ADA Curb Ramp New Construction Inspection Form (Perpendicular)

Nw 291 st

23885.56

Nw king ave

PERPENDICULAR RAMP (PR)

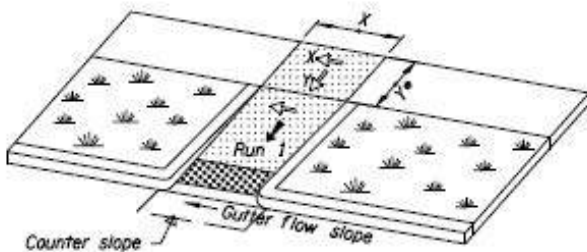
RR1 ICRR TS tool joints
